Staff Report

To: Salt Lake City Planning Commission
From: Kelsey Lindquist (801) 535-7930
Date: April 25, 2018
Re: PLNSUB2017-00926 & PLNSUB2017-01026
The Cynthia Planned Development and Preliminary Subdivision Plat

Planned Development and Preliminary Subdivision Plat

PROPERTY ADDRESS: 543 South 800 East

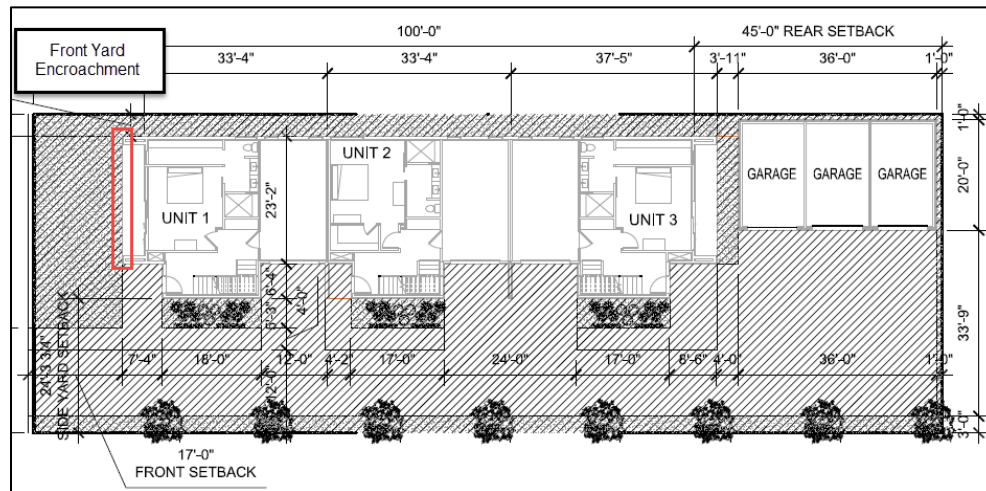
The proposed planned development encroaches into the required twenty foot (20') foot front yard setback by approximately three (3') feet. The encroachment is to accommodate a balcony extension on the street facing elevation. The balcony is to provide both for façade and pedestrian interest along 800 East. The provided front yard is approximately seventeen (17') feet with the inclusion of the balcony encroachment. The requested front yard encroachment is not consistent with the front yard setbacks surrounding the proposed development. However, the architectural interest and orientation to the public way is consistent with the surrounding development.

SITE PLAN
1"=20'-0"

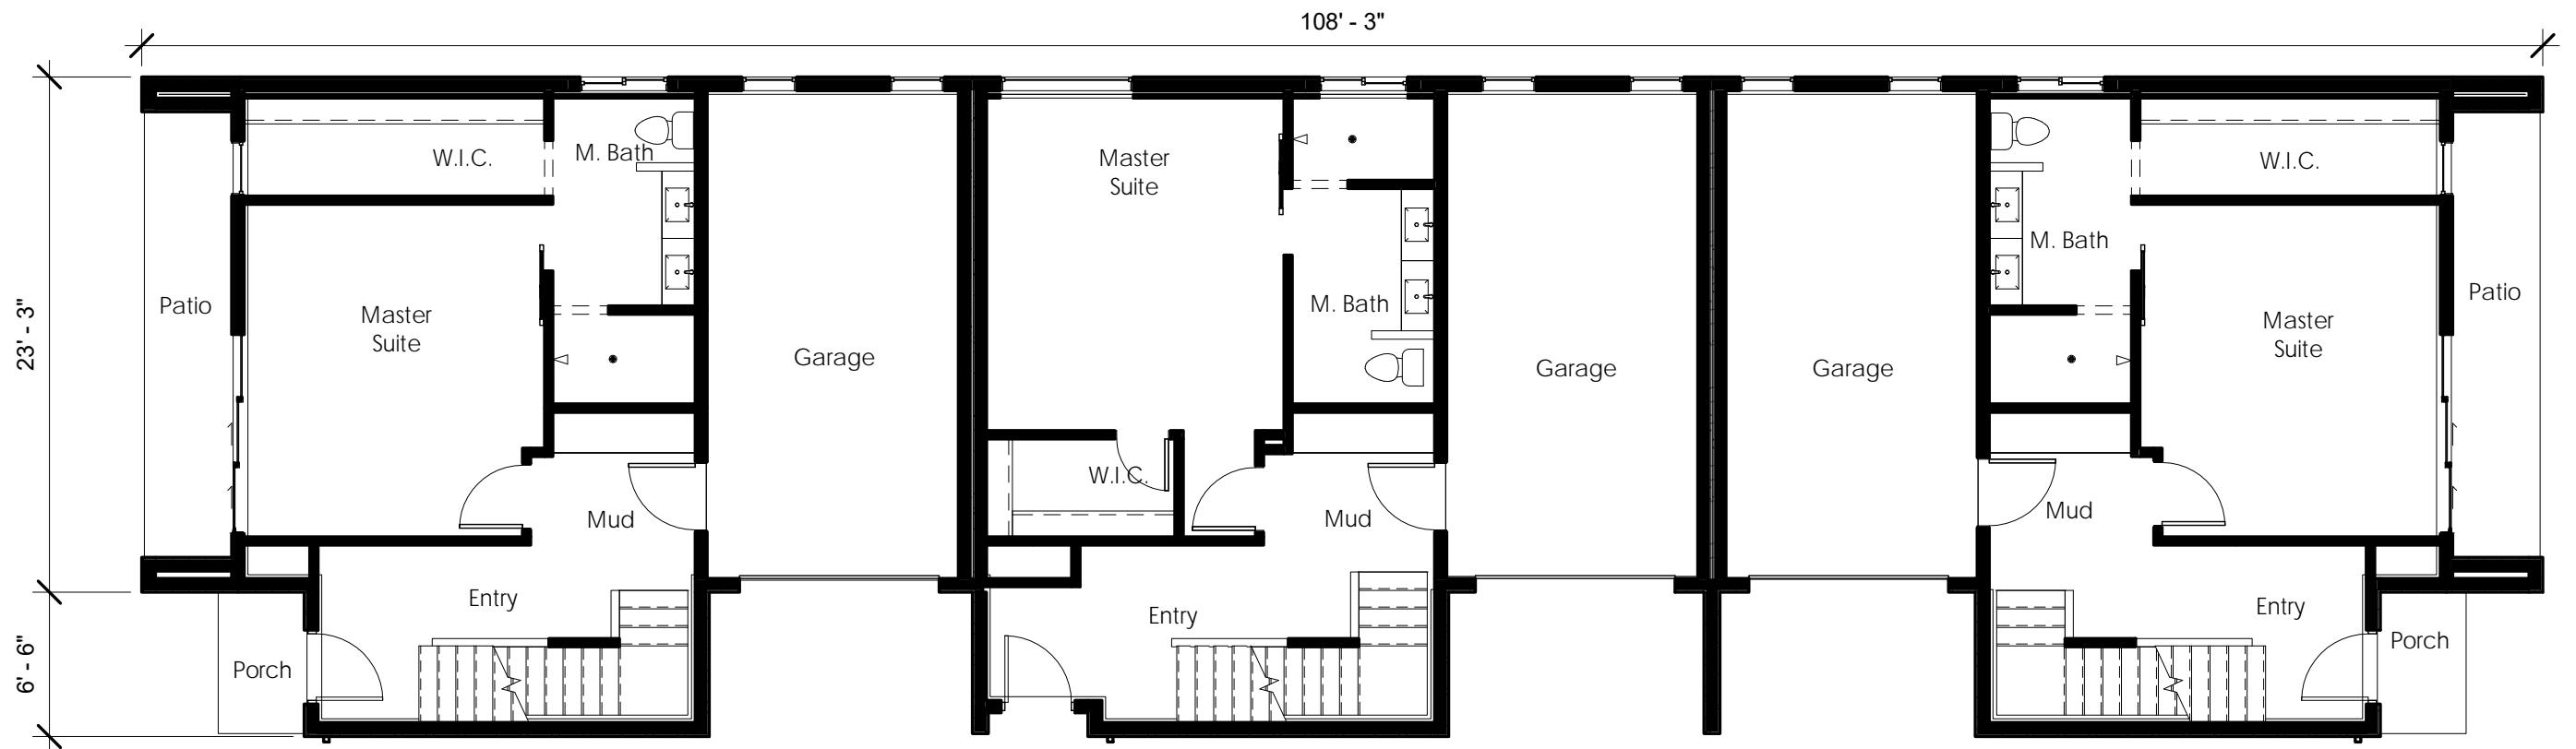
- 5) Lot 2 does not meet the minimum 3,000 square feet of lot area as required for attached dwelling units in the RMF-30 zone.
- 6) Lot coverage calculations shall be documented on the site plan. (50% maximum per lot for attached dwellings).

- 9) Consider how trash will be removed? If a dumpster is proposed show the dumpster enclosure location on the site plan.
